COMMONWEALTH EDISON COMPANY  
BYRON/BRAIDWOOD STATIONS UNITS 1 AND 2  
SYSTEM DESIGN DESCRIPTION  
FOR  
CONTAINMENT SPRAY (CS)

<u>Identification No</u>	<u>Project Nos</u>	<u>Dated</u>	<u>Rev. No.</u>	<u>Dated</u>
SDD-CS-01-BB	4391/2-45 4683/4-45	11-4-87	0	N/A

## BYRON/BRAIDWOOD UFSAR (DRP) DRAFT REVISION PACKAGE REQUEST/TRACKING SHEET

FIGURE 6.1-2

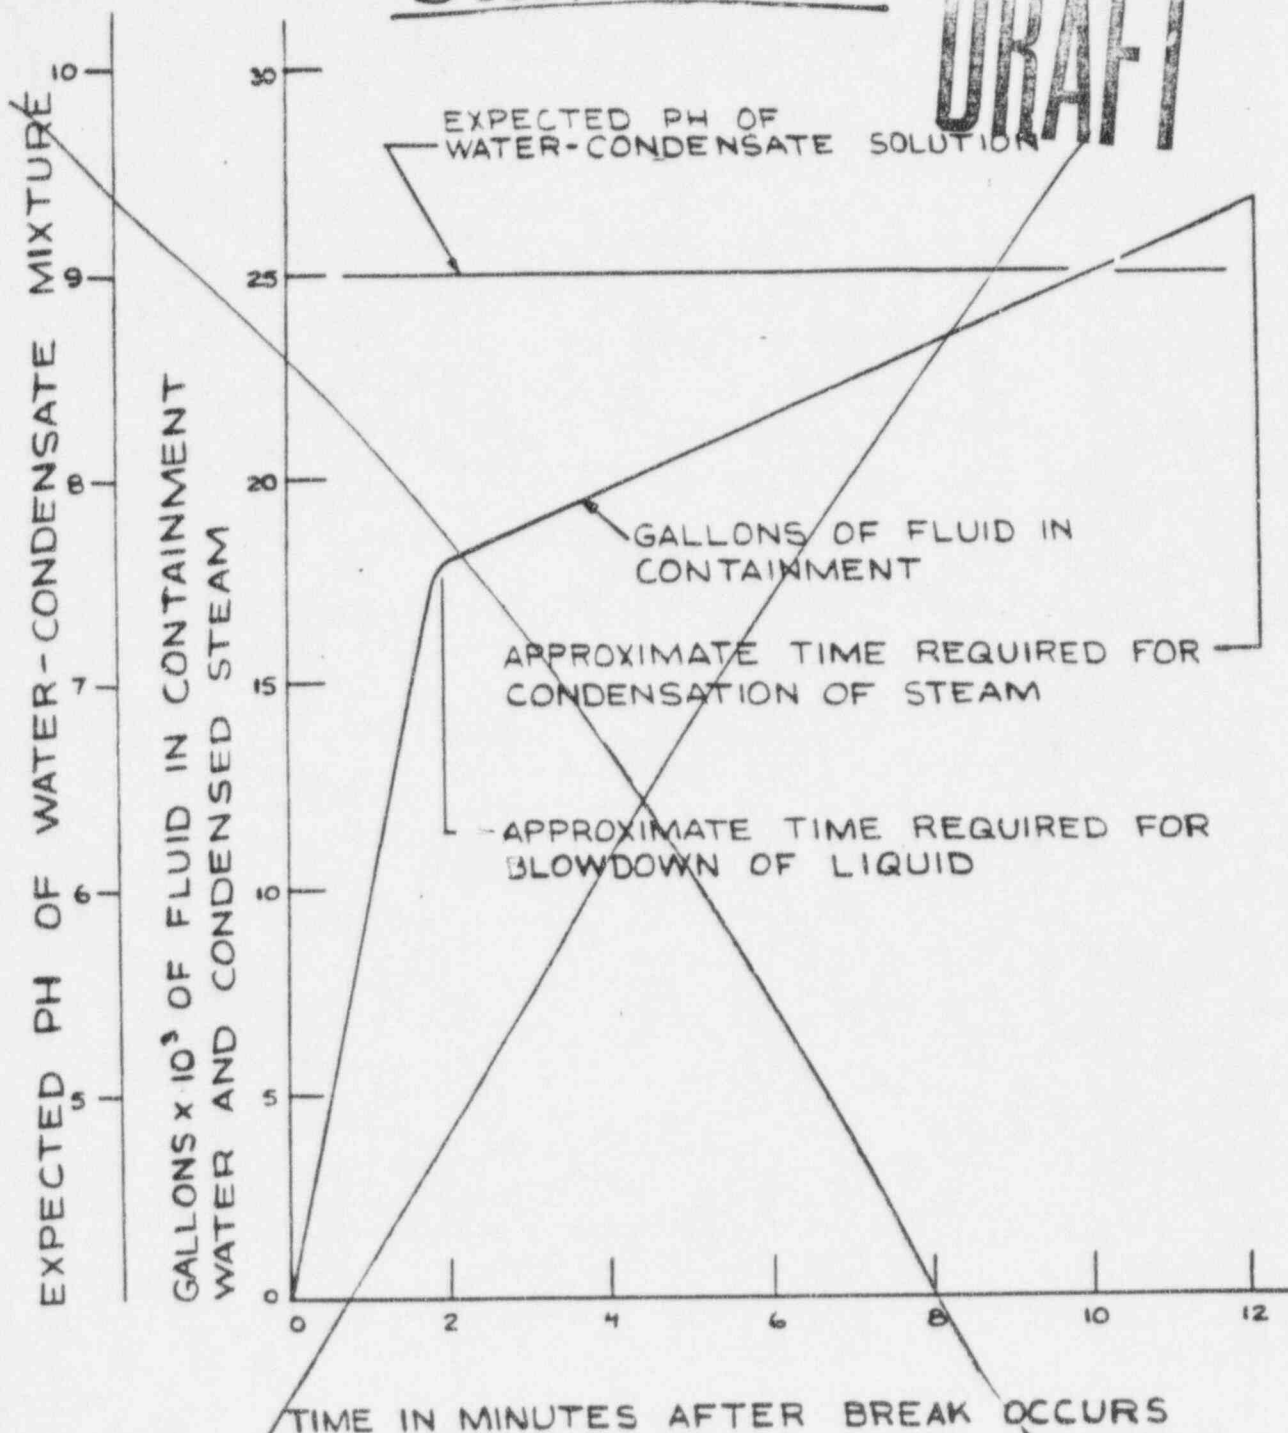
~~DELETE FIGURE~~  
AFTER 30 MINUTES

8203 LBS. OF BORON IN CONTAINMENT  
10,797 LBS. OF NaOH IN CONTAINMENT

FIGURE 6.1-3

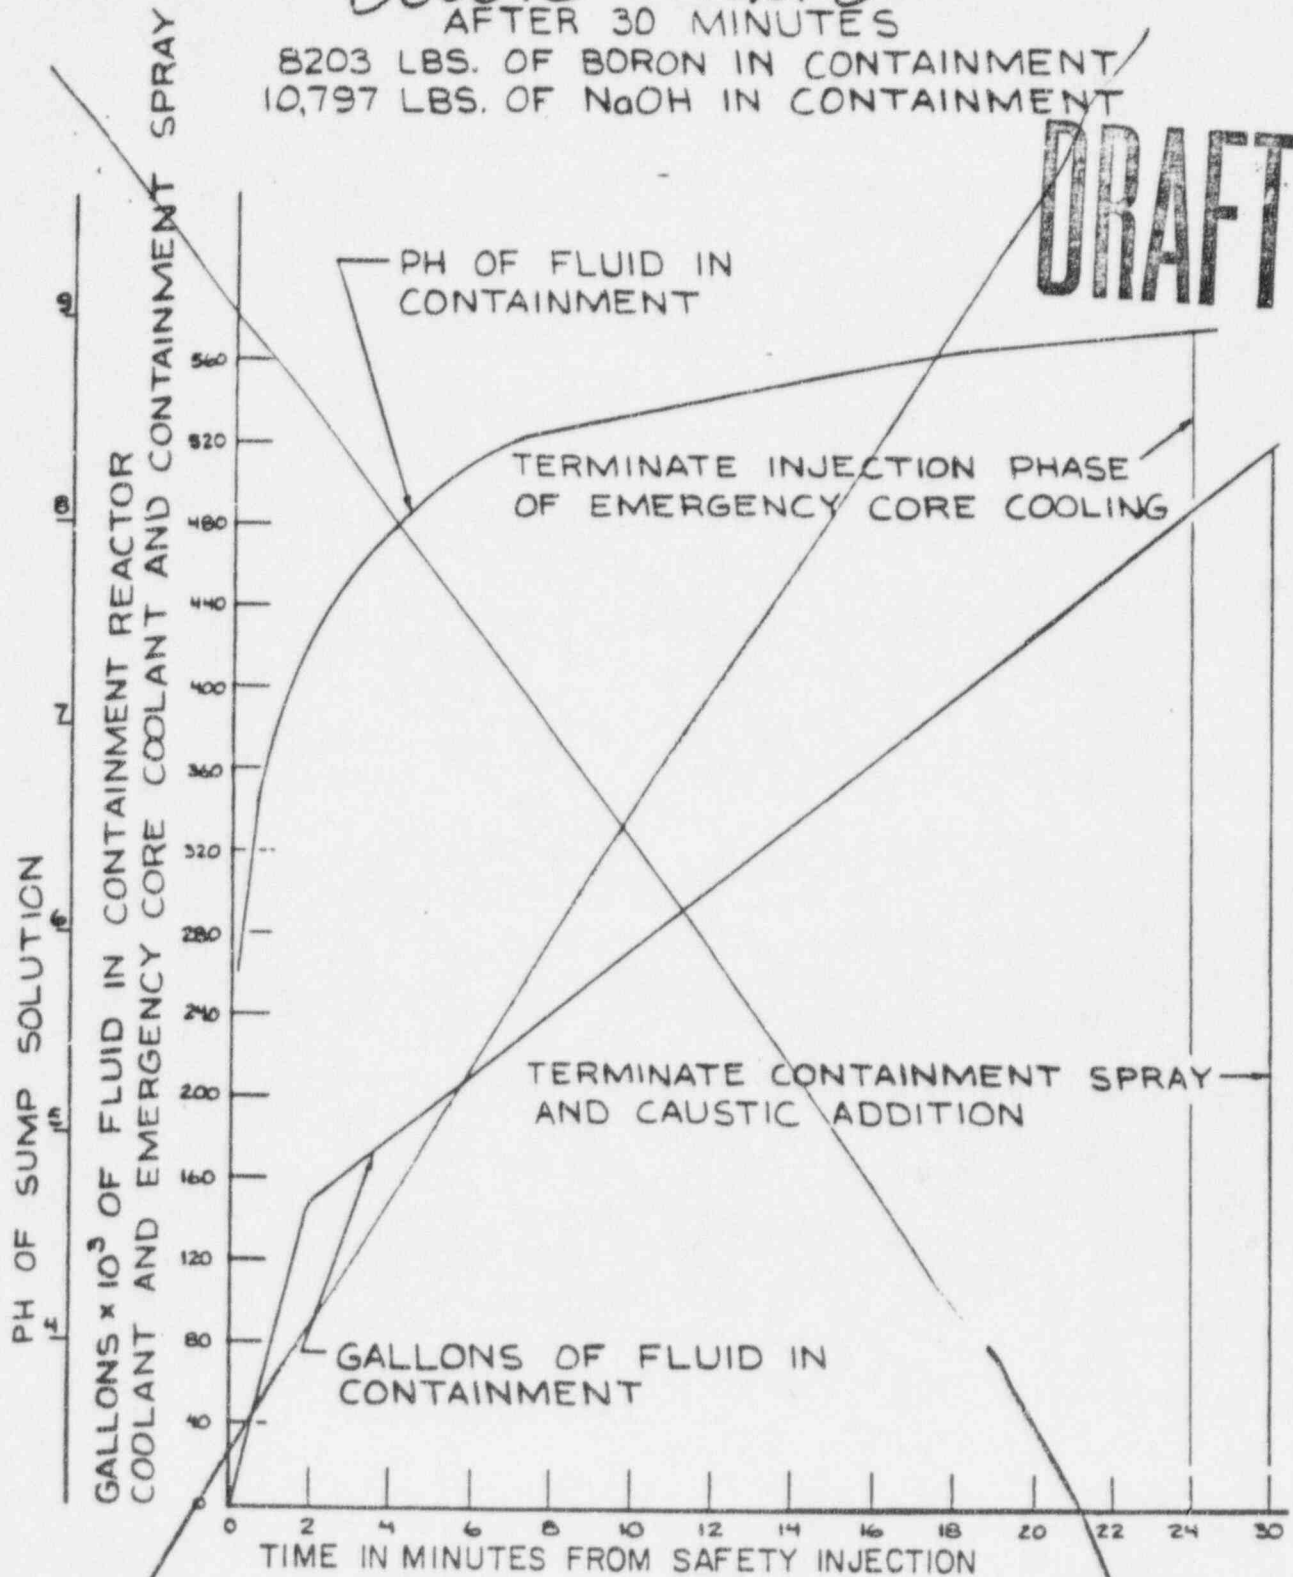
DELETE FIGURE

BYRON/BRAIDWOOD STATIONS UPDATED FINAL SAFETY ANALYSIS REPORT
FIGURE 6.1-3
FLUID AMOUNT AND pH VS. TIME, LOCA (SHEET 2 OF 2)

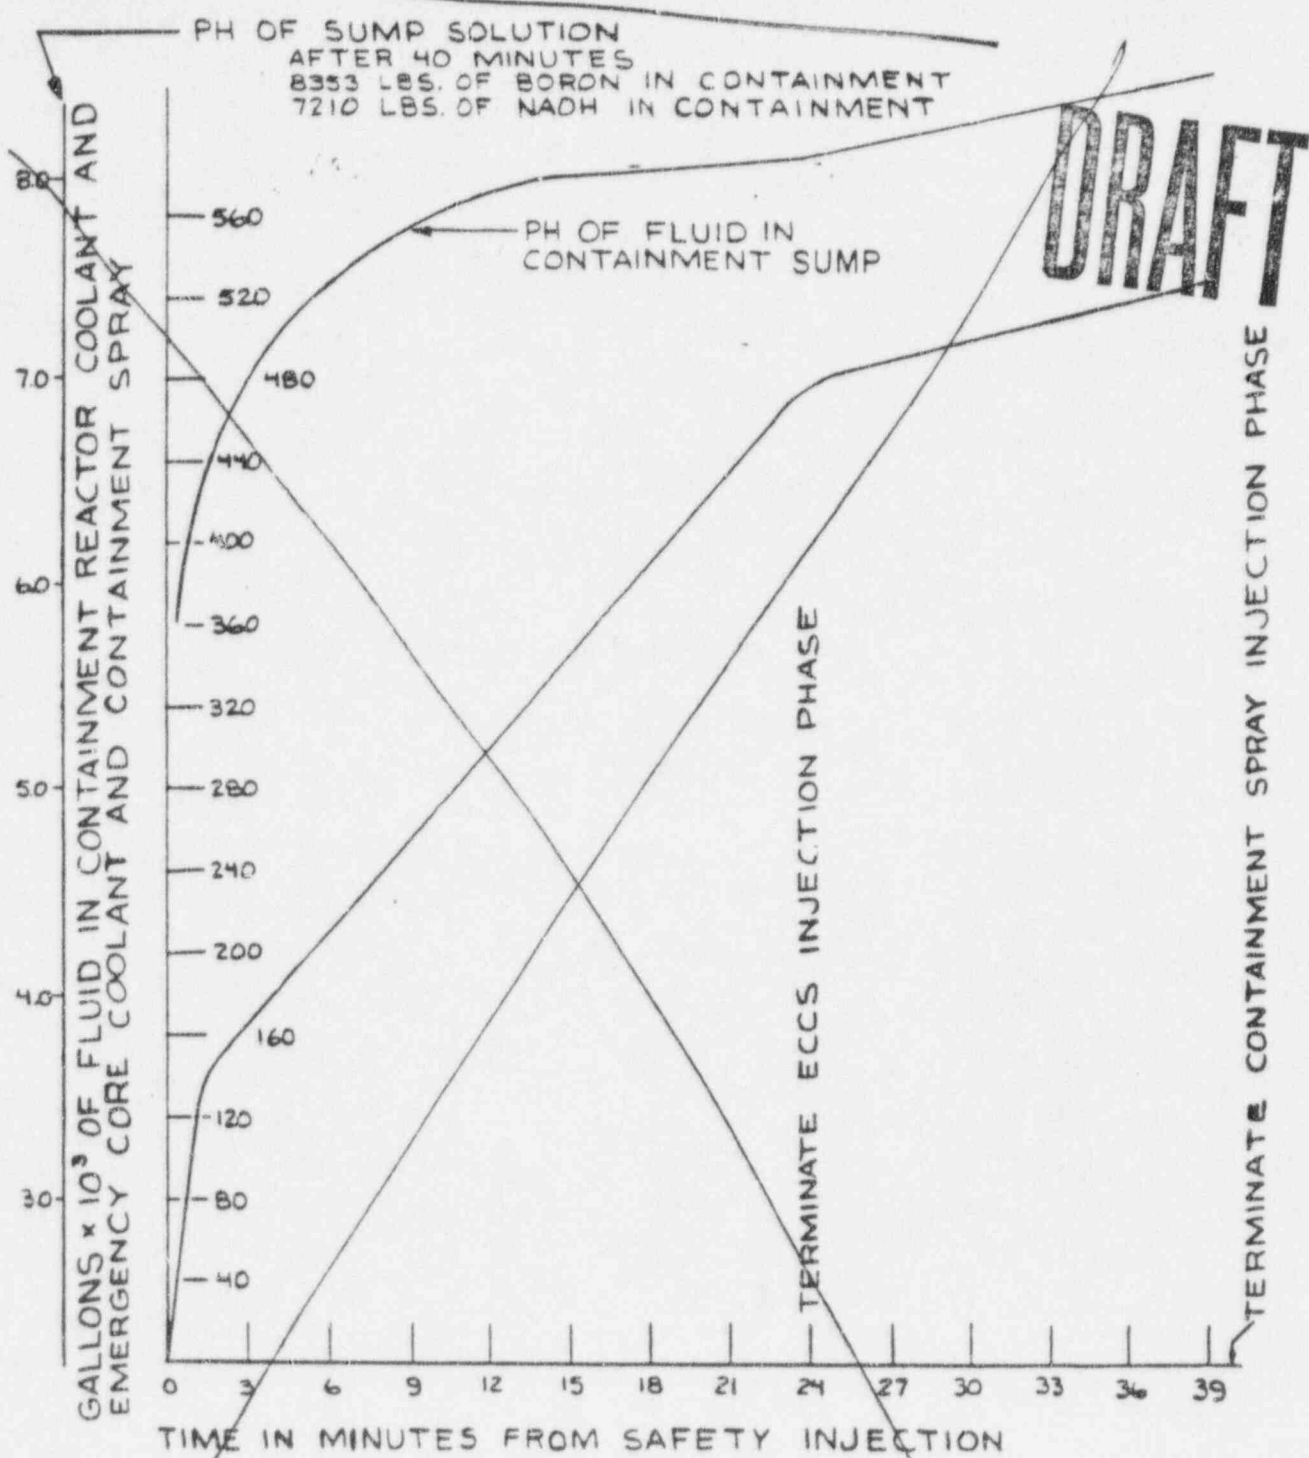
~~DELETE FIGURE~~
